BACKGROUND PLAN AS PER KOS ARCHITECTS

Dwg Number: 10687-E-02-TH-1099(3)

Responses to L&P Comments 27.01.2021

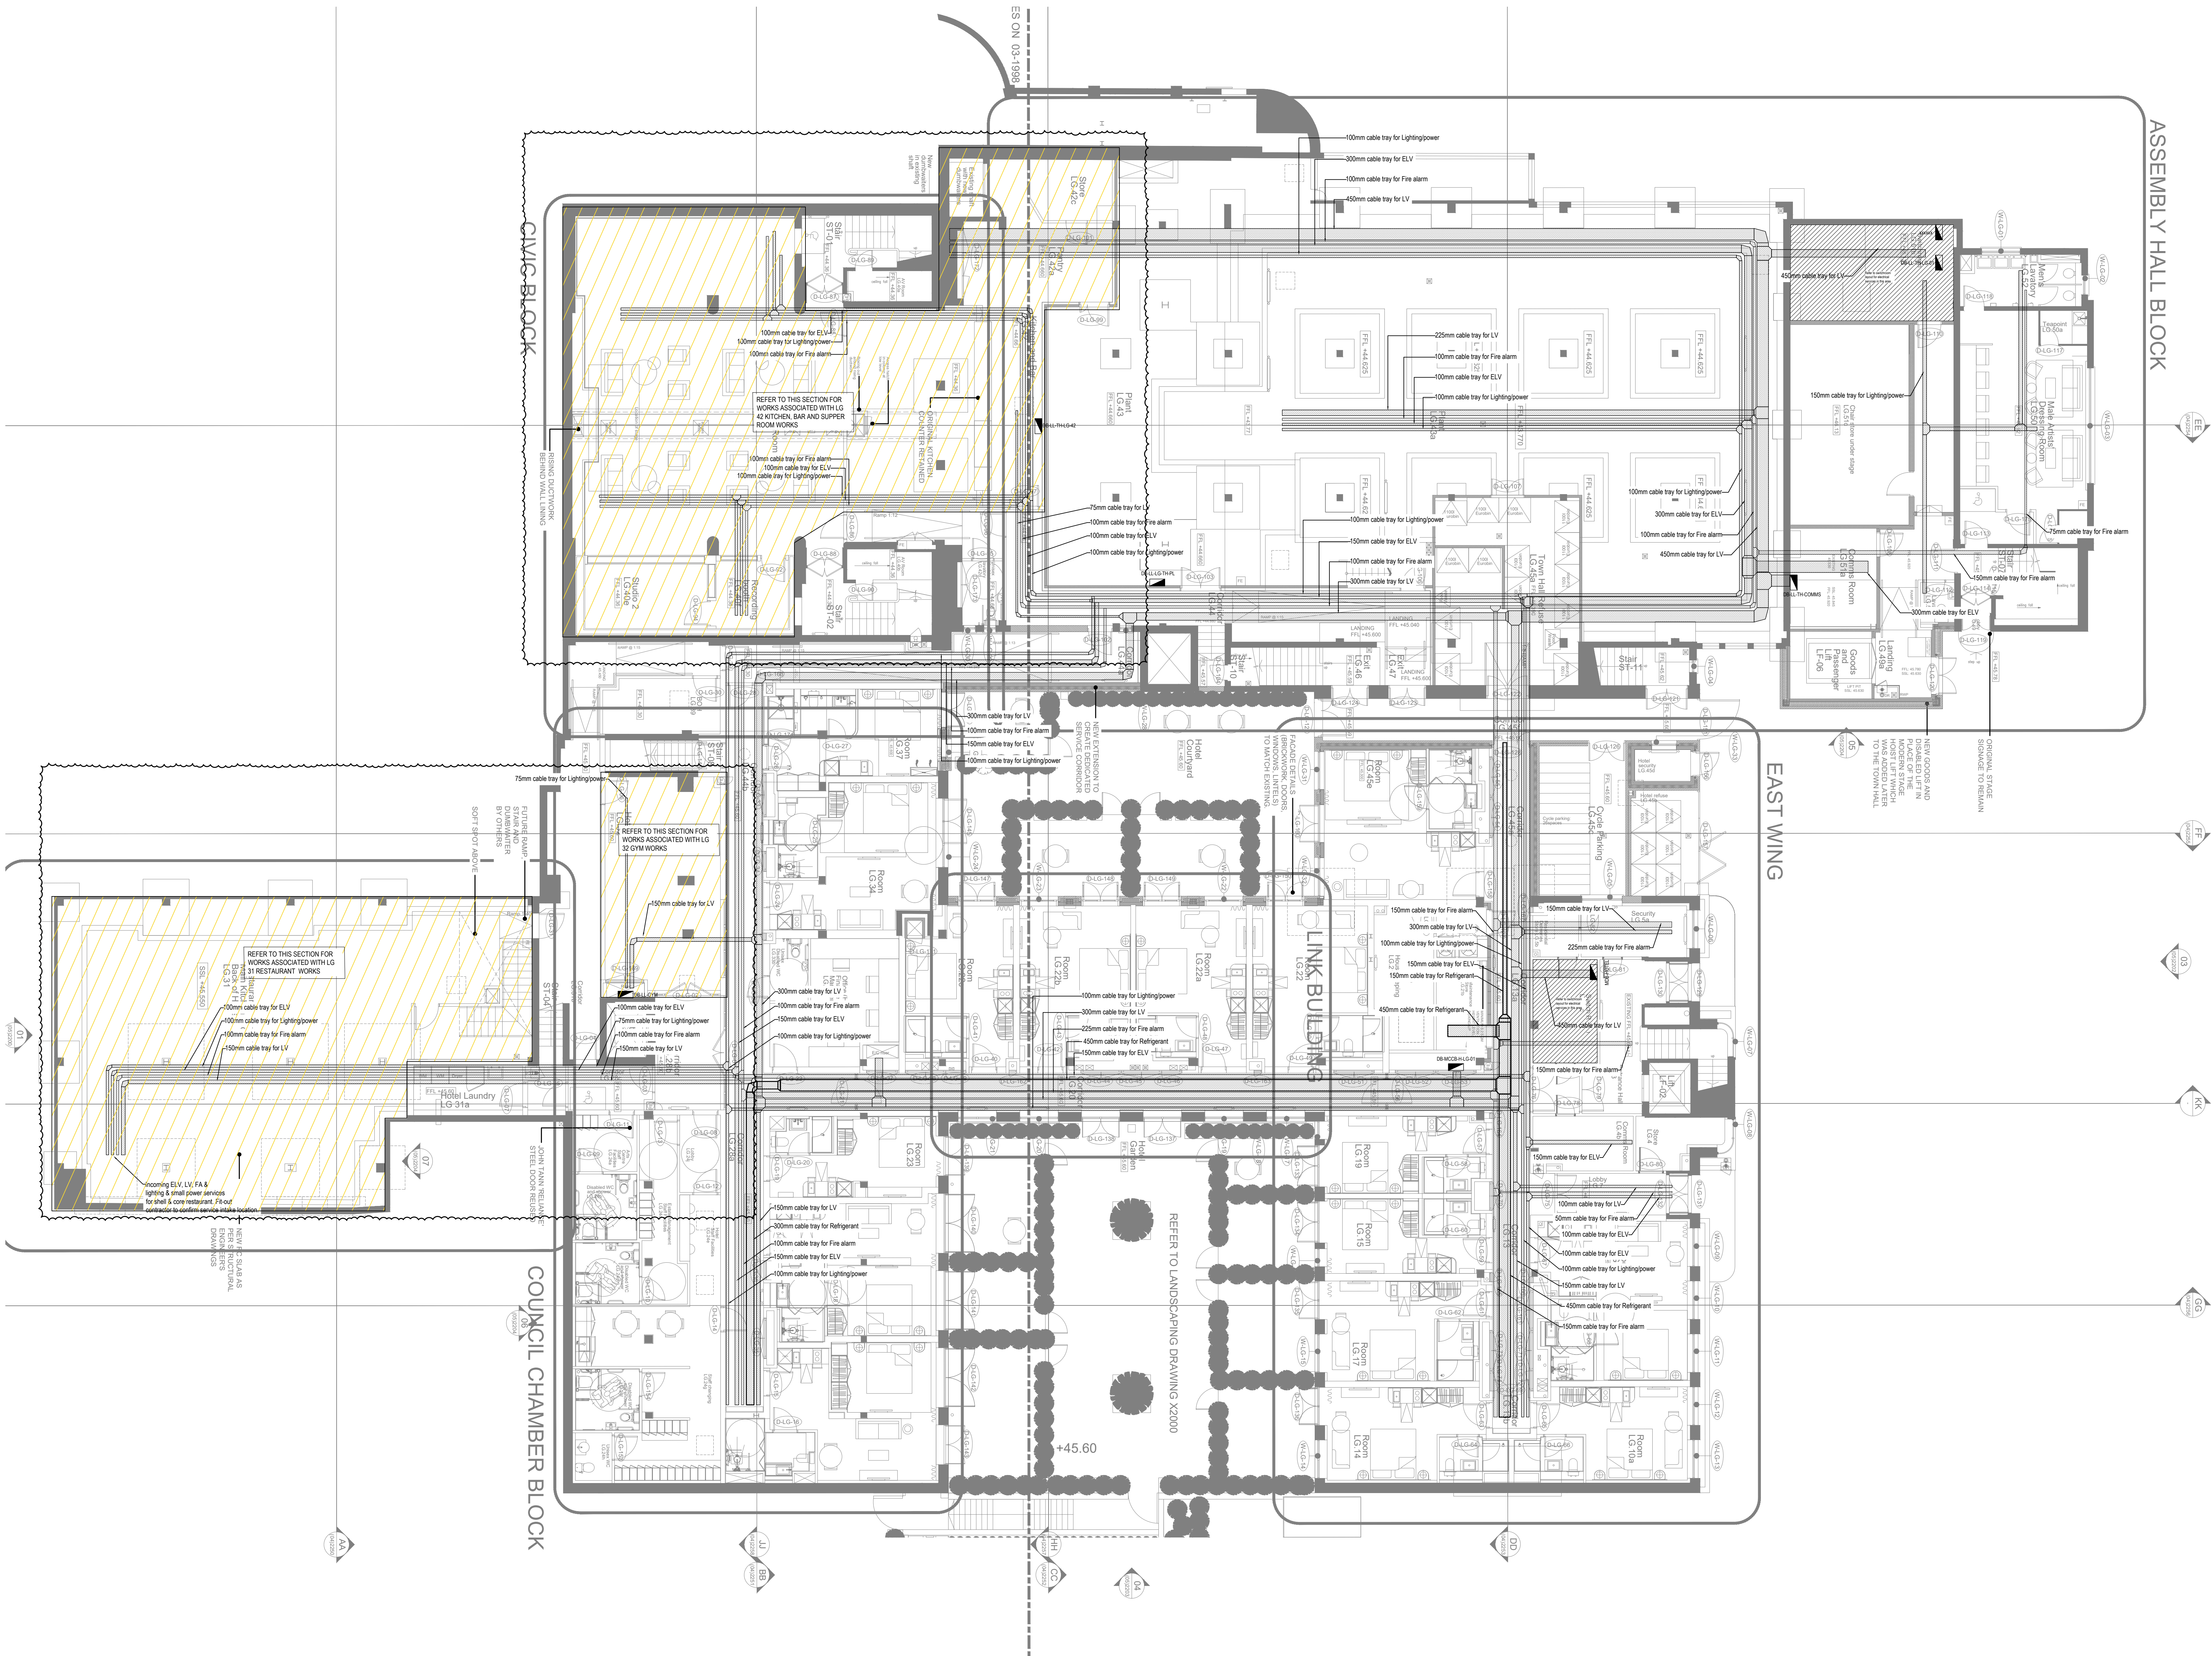
1. Please provide coordinated sections and details along corridor route, within rooms. This is to verify how access is maintained to all containment. See combined distribution details drawings.

2. Also to verify co-ordination with other services. Main Power cabling cannot be installed to ceiling but to floor in an escape route under Base Building Regulations. See combined distribution details drawings.

3. Please depict level levels for each section of containment. See combined distribution details drawings.
4. Containment needs to extend from riser board and must not stop short with isolated sections shown. This has been updated.

5. Provide a series of drawings demonstrating containment using capacity and space for each section. This does not fall under our scope, schedules are available to ascertain amount of cable per tray and space capacity can be determined from this.

6. Provide fire stopping details. By others.
7. Provide fire stopping details at each trapping section. By others.
8. Provide support installation details. See combined distribution details drawings.

9. Demonstrate how containment concealed from view but fully accessible - All areas. By others.
